United States Department of the Interior

April 9, 2024

In Reply Refer To:
FWS/R4/ES/DCN080741

Independent Technical Review of the Revised Twin Pines Permit Application Hydrologic Modeling

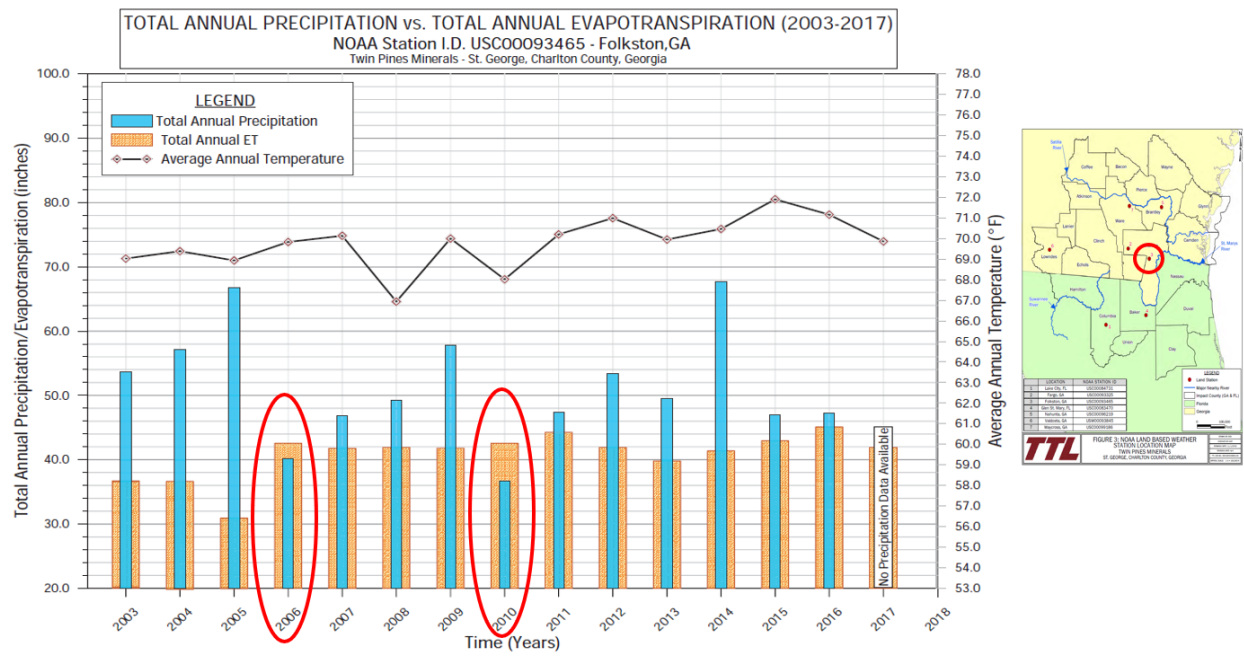
This modeling attempt assumes that lowering recharge rate from 4.13 inches/year (representing ‘average’ conditions) to 3.5 inches/year is appropriate to simulate ‘dry’ conditions. This is simply unrealistic. As can be seen in Figure 1, 3.5 inches per year of recharge does not accurately represent dry conditions, when the recharge values should be *negative*.

FIGURE 2. DAILY PRECIPITATION DATA AT FOLKSTON, GA, FOR 2-YEAR PERIOD.

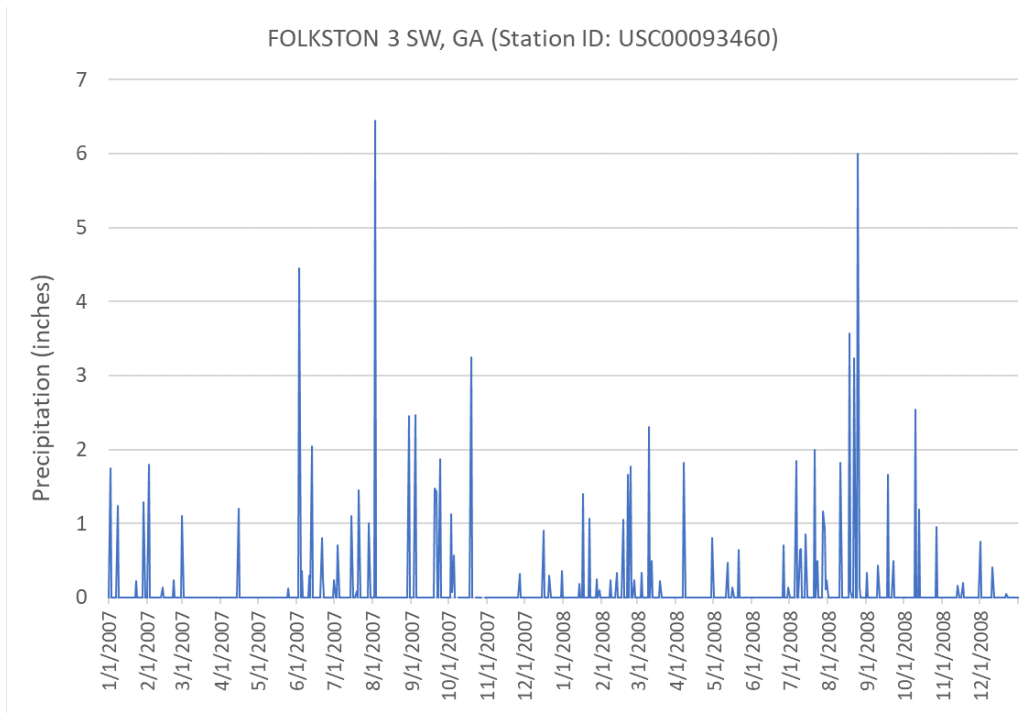
Figure 1 and Figure 2 in this report illustrate the substantial daily, seasonal, and interannual variability in precipitation within the region, emphasizing the importance of incorporating spatiotemporal variability in recharge rates into the model. It is critical to appropriately represent the drought conditions in the models for evaluating the mining impacts on ONWR, particularly during extreme events.

FIGURE 3. LOCAL HYDROLOGIC SUB-BASIN DELINEATION AND SURFACE HYDROLOGY WITHIN ONWR. THIS MAP IS REPRODUCED FROM (ZENG, 2023). THE BROWN SHADED AREA IN THE LOWER RIGHT OF THE FIGURE SHOWS THE SOUTHEAST COMPARTMENT OF THE OKEFENOKEE SWAMP.

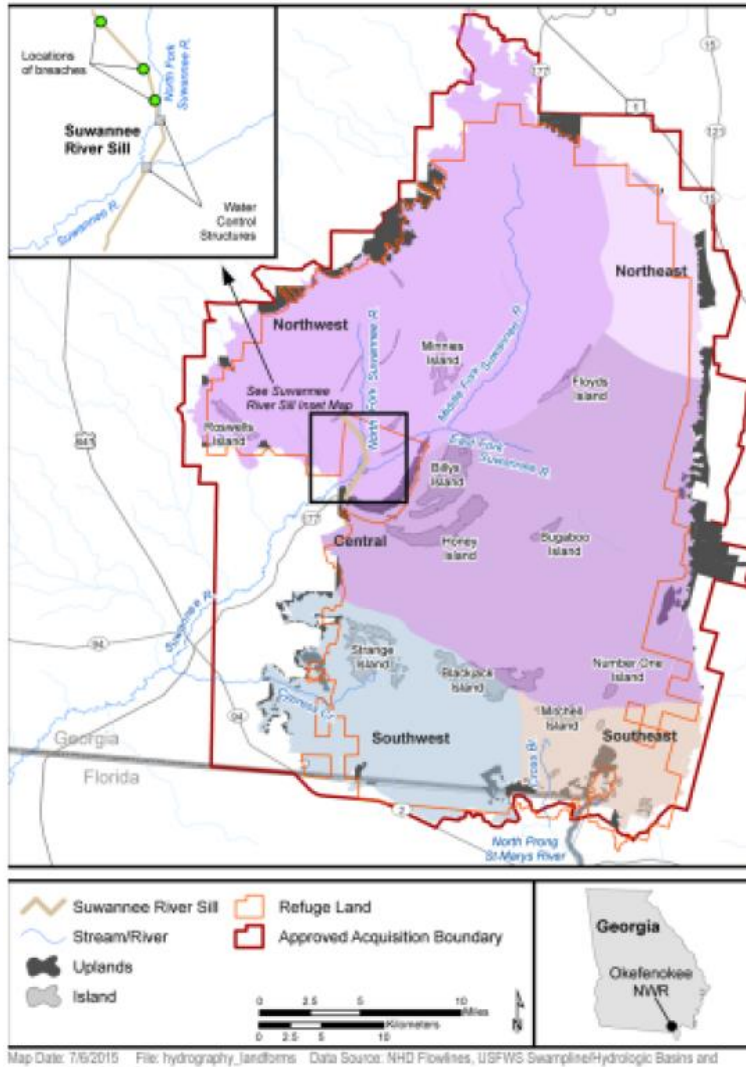
It is unclear why the analysis was done on the southeast *quadrant*, which was assumed to be 25% of the ONWR. In (Zeng, 2023), GA-EPD did an assessment using the Southeastern *Compartment* of the ONWR (Figure 3), which was estimated to be only 6% of the volume of the ONWR. The volume of the southeast quadrant of ONWR is substantially larger than the southeast compartment. Any analyses should make explicitly clear what is meant by 'southeast' so appropriate conclusions can be made regarding any results provided.

In addition, this analysis by GSI again uses annual average values, which cannot be used to quantify potential impacts to the ecosystems of ONWR.

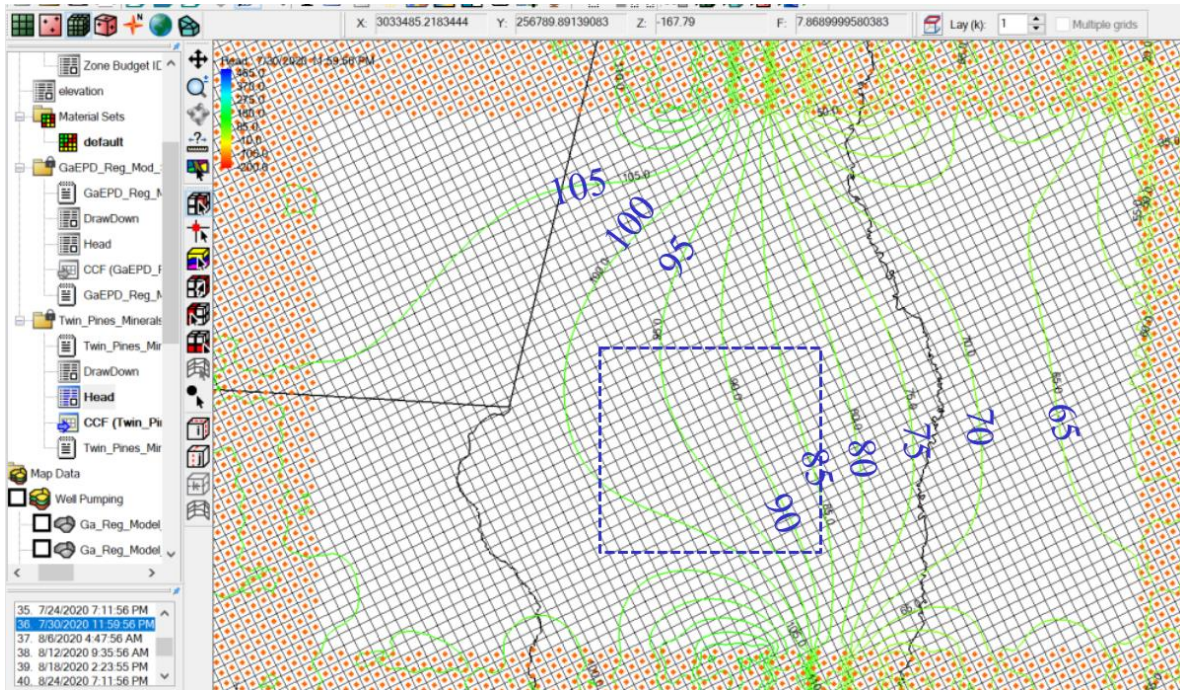
1. The two contour surfaces for January 1, 2020, and for July 30, 2020, are exactly the same. The likelihood of not having at least a small amount of variation in the location of the isolines seems minimal. This issue causes concerns that the State Water Plan transient model is not capable of modeling seasonal differences, or that there was potentially an error in the presentation or interpretation of the model results. This is discussed in more detail in (Bahm & Paudel, 2023). For example, in (Bahm & Paudel, 2023), Figure 16 shows groundwater elevation and precipitation for station PZ-01 (close to Trail Ridge) clearly depicting the considerable difference in groundwater levels in June and July (e.g., greater than 4 ft.). This contradicts the claim that *“The lack of change in hydraulic heads between January and July indicates that a steady state model could be used to simulate conditions at the mine”* made in Zeng, 2023.

2. The units on the isolines lines are not given, but as can be seen in Figure 4, the values around Trail Ridge only reach a maximum of 105. If these units are presumed to be feet, they are nowhere near the actual stages along Trail Ridge which have a measured range from

3. If the isolines denote stages in feet, the contour surface in Kennedy's model around Trail Ridge (Figure 4) has the highest stages in the west and the lowest stages in the east, with a constant decreasing slope in between. The model does not show a hydraulic ridge in the Trail Ridge area. Actual stage measurements in the area show Trail Ridge with high stages (~160-170 ft) along the centerline of the ridge, with decreasing stages towards the east and west (see measured groundwater surfaces in Figures 7, 8, and 9 in (Holt R. M., Tanner, Smith, Patton, & Lepchitz, 2019-lb)).

GA-EPD should provide more detailed documentation of their model and Kennedy's analysis and substantiate their conclusion that steady-state modeling is appropriate. With the information currently provided in Dr. Kennedy's letter to Mr. Wiedl, this argument appears flawed.

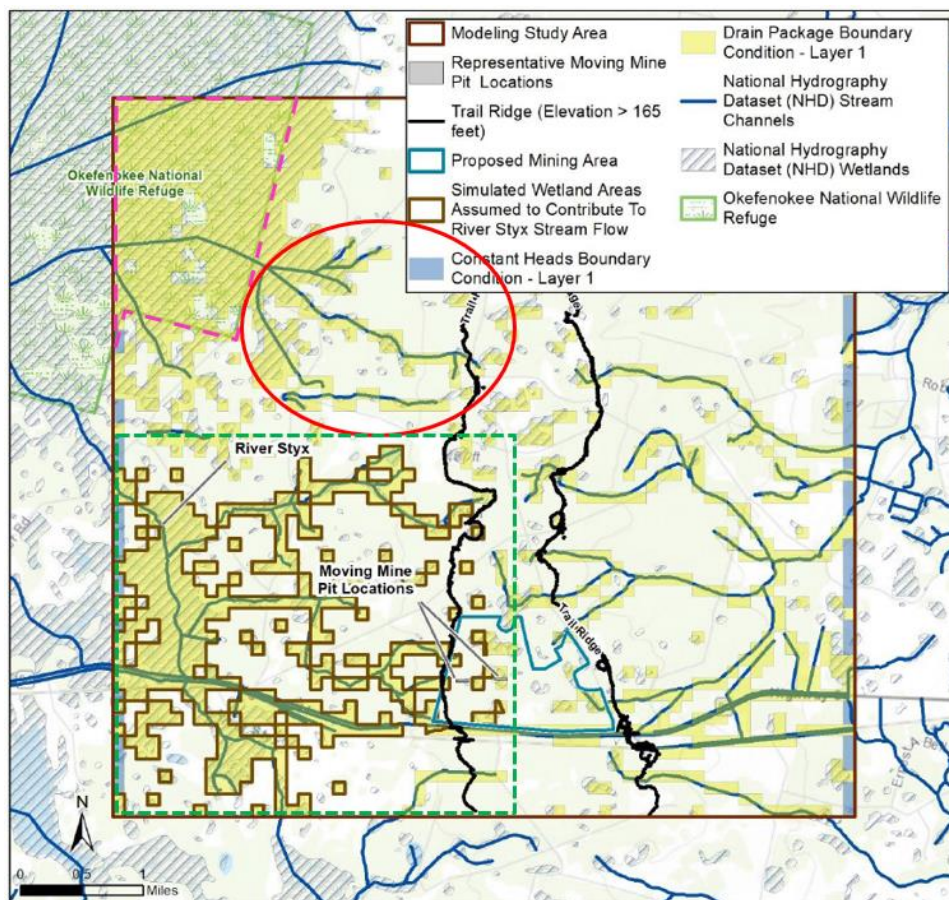
It is unfortunate, however, that GSI went back to using the incorrect analysis method for its analyses in Section 4.8 of (GSI, 2023-W), where they again quantified changes in flows north of the mine instead of directly downstream of the mine (where the effects on ONWR are most likely to occur).

DRAIN CELLS (YELLOW) IN THE MODEL. THE PINK DASHED LINE INDICATES THE DRAIN CELLS THAT WERE USED TO QUANTIFY CHANGES IN FLOWS TO ONWR IN (GSI, 2022-O). FLOWS FROM CELLS WITHIN THE RED CIRCLE (UPSTREAM OF THE PINK DASHED AREA) THAT WOULD HAVE EVENTUALLY REACHED ONWR WERE NOT CONSIDERED IN THOSE ANALYSES. MORE IMPORTANTLY, IN (GSI, 2022-O), FLOWS FROM DRAIN CELLS WITHIN THE GREEN DASHED SQUARE THAT WOULD FLOW DIRECTLY FROM THE MINING SITE INTO ONWR WERE OMITTED WHEN QUANTIFYING IMPACTS OF THE MINE ON ONWR. IN A SUBSEQUENT ANALYSIS FROM (GSI, 2023-W), THIS ERROR WAS CORRECTED, BUT YET ANOTHER ANALYSIS IN THE SAME REPORT REPEATS THE ERROR.

FIGURE 7. MODEL OUTPUT FROM THE GSI STEADY-STATE MODEL SHOWING PREDICTED MINING EFFECTS EXTENDING TO THE SOUTHERN BOUNDARY OF THE MODEL DOMAIN. REPRODUCED FROM FIGURES 4 AND 9 IN (GSI, 2023A). RED CIRCLES ADDED BY THE AUTHORS OF THIS REPORT.

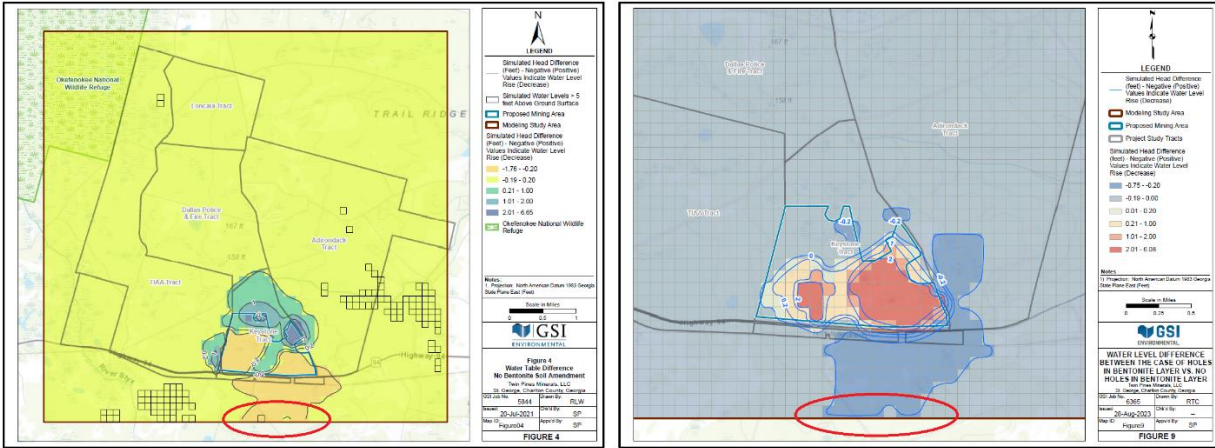
NPS maintains its concern that the positioning of the no-flow boundaries is a problem with the GSI model. Proper modeling practices state that the boundaries should be far enough away from the area of interest being modeled that the impacts of the area will not reach the boundary. Figures 4 and 9 of (GSI, 2023a) depict model output of head difference maps that clearly show predicted effects reaching the southern boundary of the model. These graphics are reproduced in Figure 7 of this report.
